Title: Cavalon window strength improvement		
AG-SB-2022-08-C-EN	Effective Date: 26.09.2022	Compliance Category:
Applicability		A – MANDATORY B – RECOMMENDED C – OPTIONAL
Aircraft type & model: AutoGyro Cavalon	Affected Serial number(s): Up to SN V00533	
The maintenance manual to be referenced is this stated or subsequent issue.		As per AutoGyro website
This form is the response from AutoGyro GmbH either against a problem found in the product in service requiring a containment or rectification action, or as service information for aircraft modification incorporation. For help, contact airworthiness@auto-gyro.com.

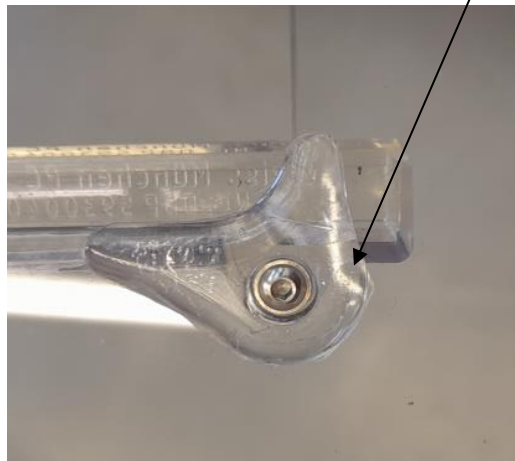
Due to improper opening and closing of the door via the ventilation window, cracks occasionally occur at the front lower corners of the ventilation windows at the screw connection.

In order to prevent cracks on the Cavalon cabin door, reinforcements have been developed to evenly distribute stress and stiffen critical areas of the cabin door.

- Uninstall the lower front screw
- Clean the outside surface of the cabin door with active glass cleaner (PN 30494)

Install reinforcement:

- Clean the surface of the reinforcement with Loctite 7063 Super Clean (PN 35915)
- Add the double-sided tape on the reinforcement
- Line up contour and hole of the reinforcement and cabin door when installing
- Put the screw back on

Tighten screws only hand-tight
